VIRGINIA ELECTRIC AND POWER COMPANY  
RICHMOND, VIRGINIA 23261

Serial No. 725A  
NO/WLT/JOE:ms  
Docket No. 60-338  
License No. NPF-4

REQUEST FOR ADDITIONAL INFORMATION  
ELECTRICAL DISTRIBUTION SYSTEM VOLTAGES  
NORTH ANNA POWER STATION

GEN 1  
DEIBKR

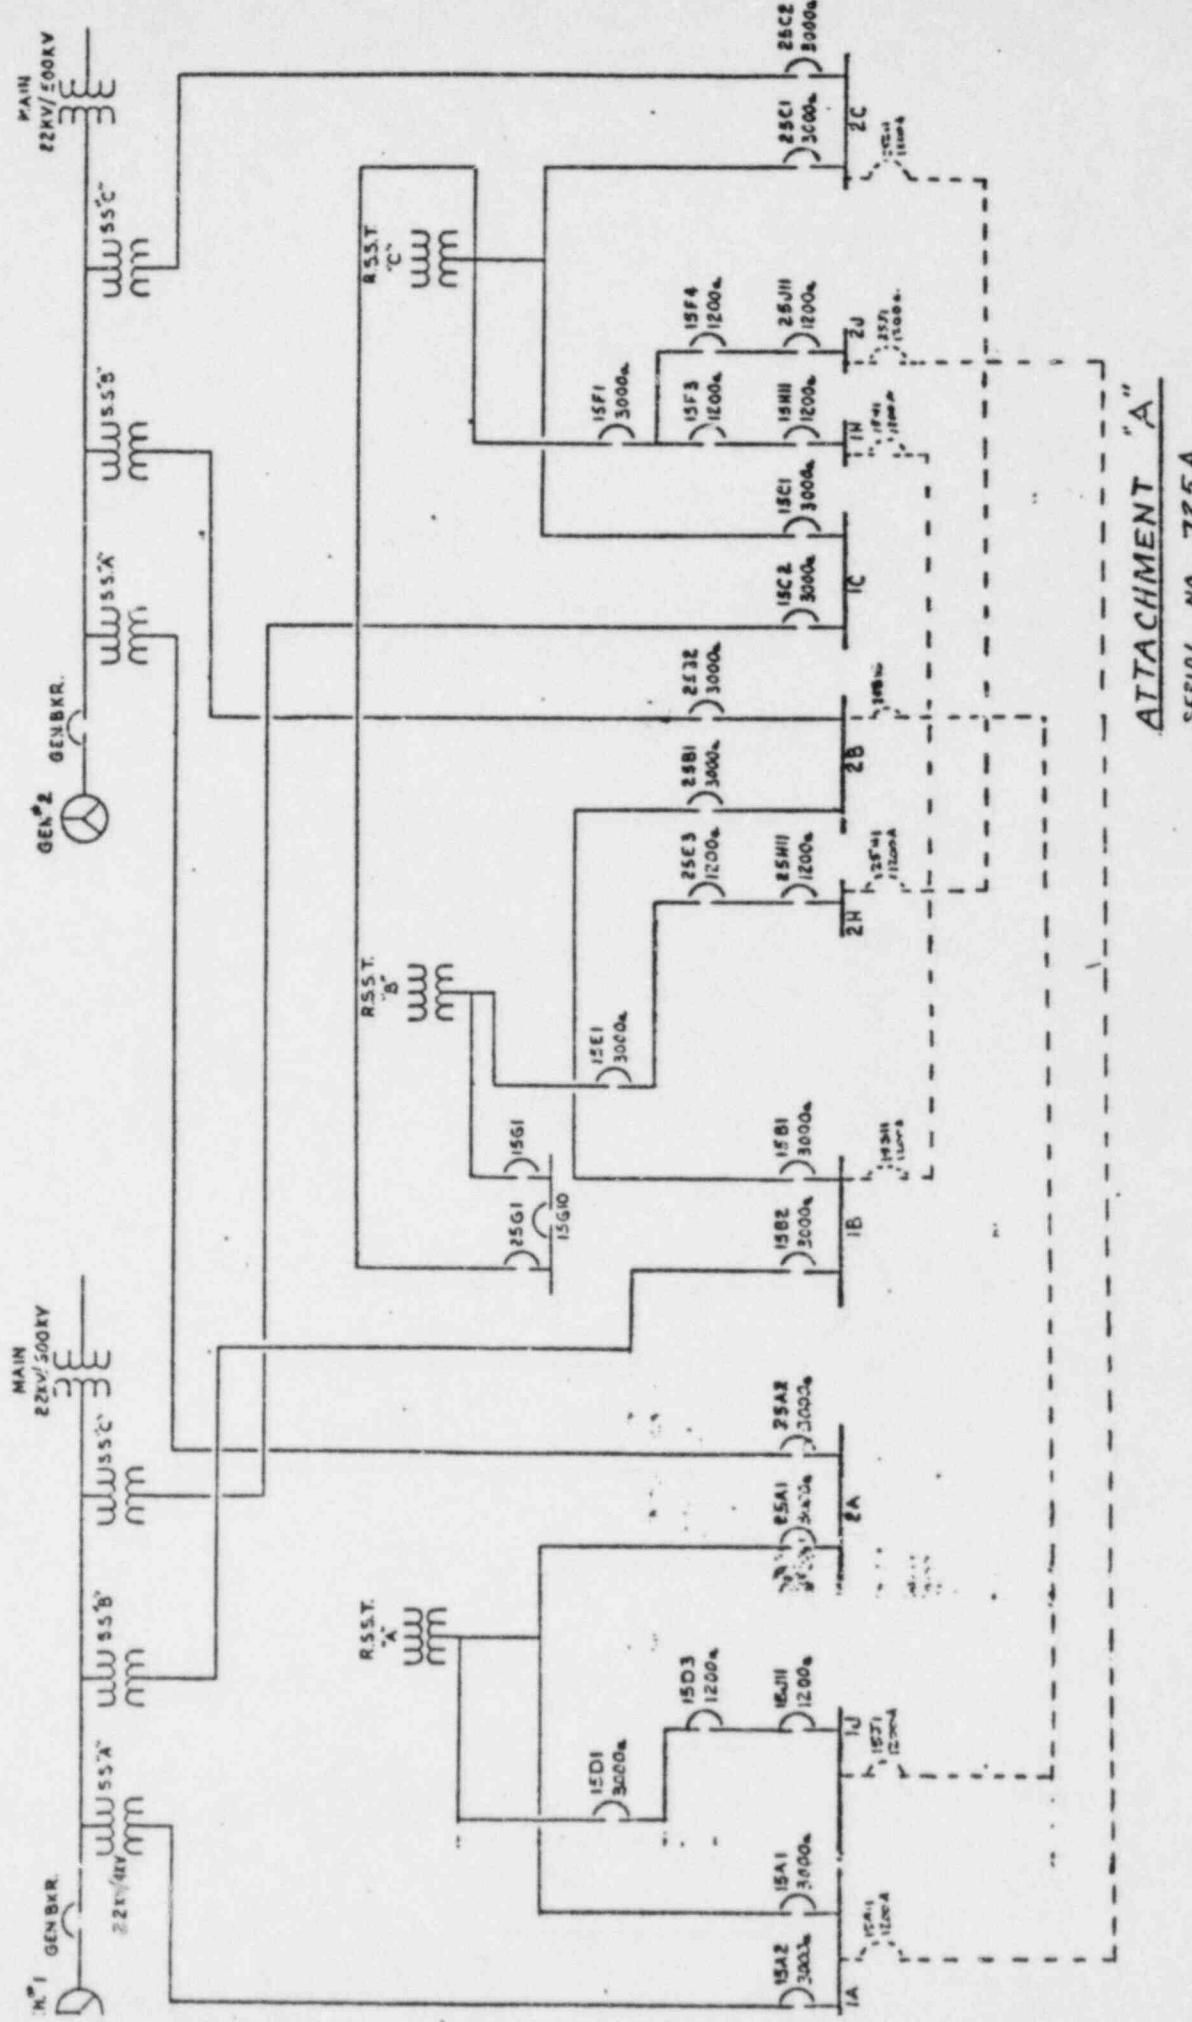
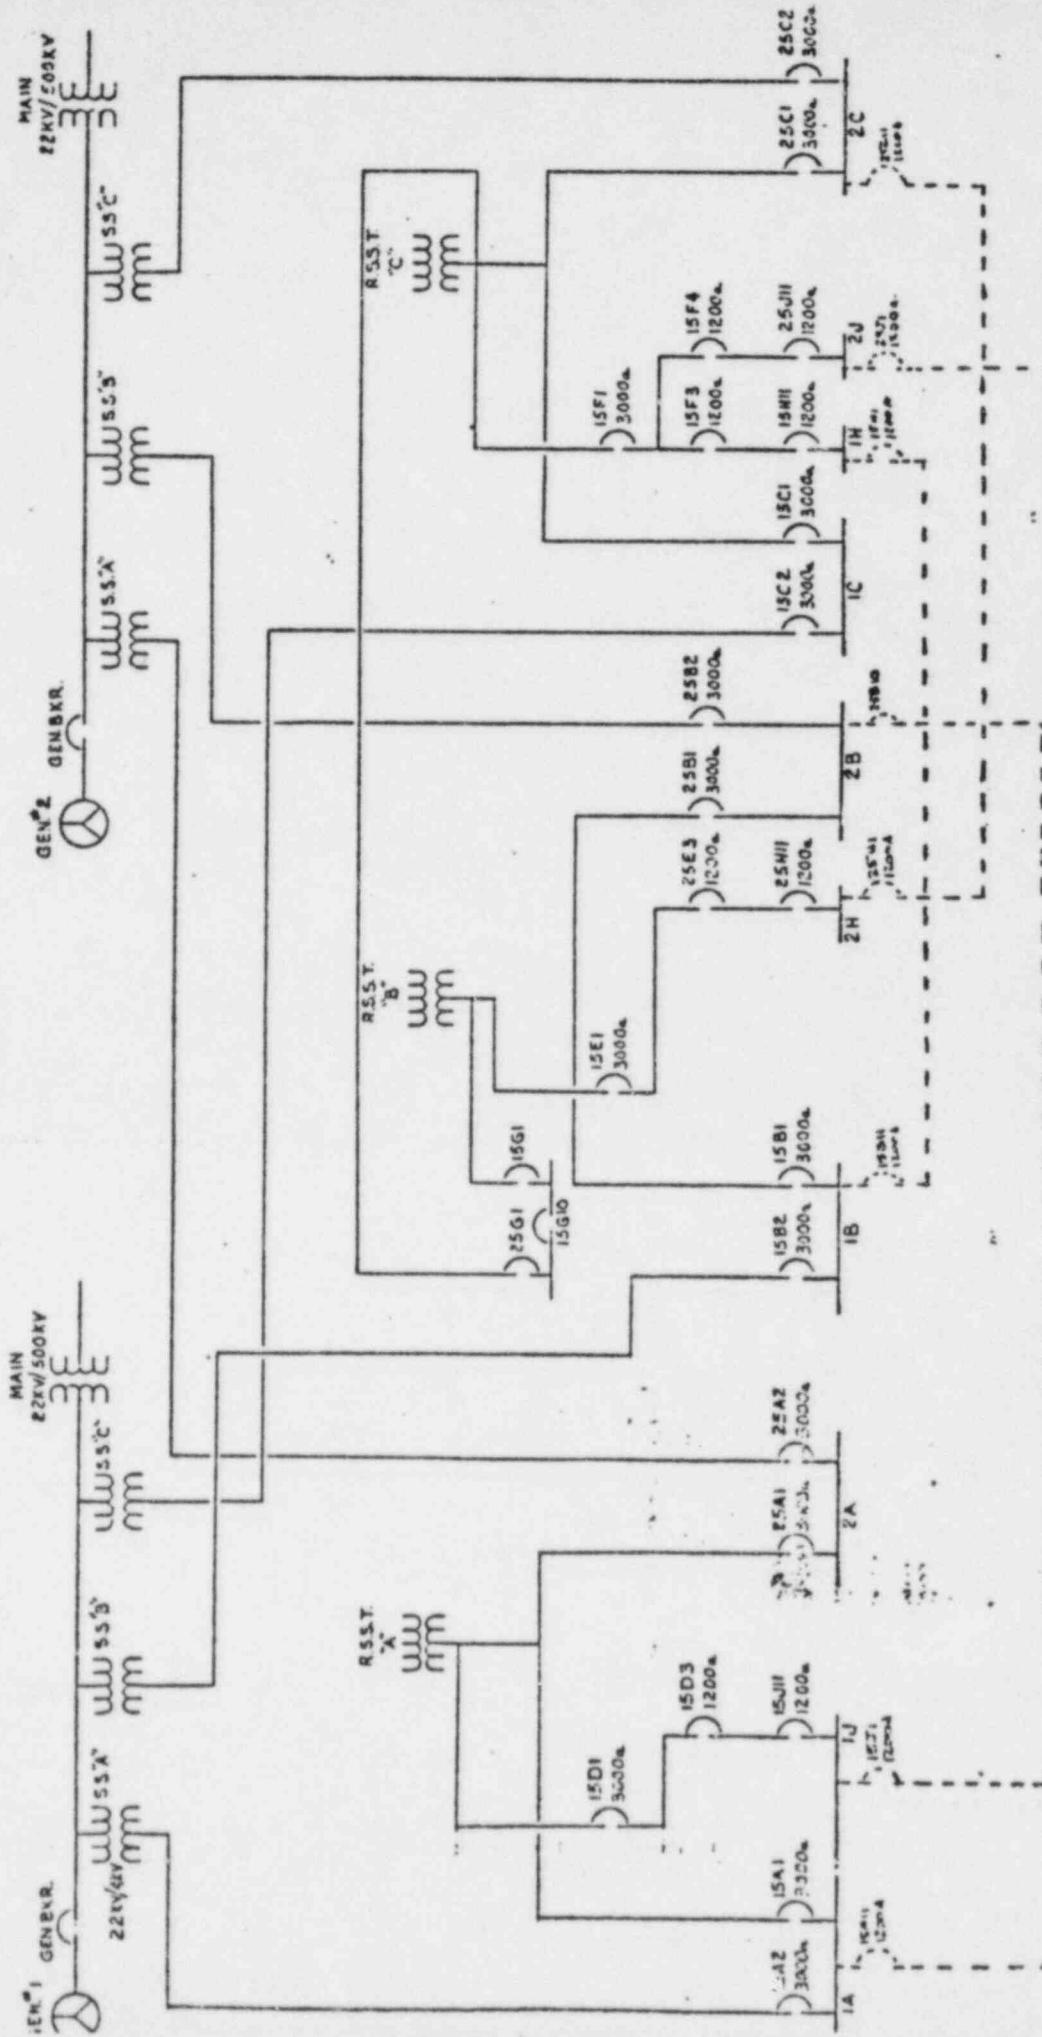
Our analysis has shown that the installation of circuit breakers between the generator and the station service transformers will provide tremendous flexibility and capability in offsite power supplies. Attachment A to this letter is a one-line diagram of our planned future system. This arrangement will allow unit start-up with auxiliaries powered through the normal station service transformers. It will also curtail the need to transfer auxiliary loads to the reserve transformers for most unit trips. Therefore, it will be inconceivable that the loading on the reserve system could ever approach the postulated values in our previous studies.

One additional benefit of the generator breaker would be that it provides an additional offsite power supply through the main transformer and the station service transformers. By installing a generator breaker in each unit at North Anna, we will have four independent power supplies from the 500KV bus to the two units' auxiliaries. This advantage will be utilized by providing an alternate tie to each 4KV emergency bus from a normal station service bus.

The design for the modifications discussed above for North Anna Units 1 and 2 is proceeding. Installation will occur at the earliest practical date. Further information on this modification will be forwarded to you in a later submittal.
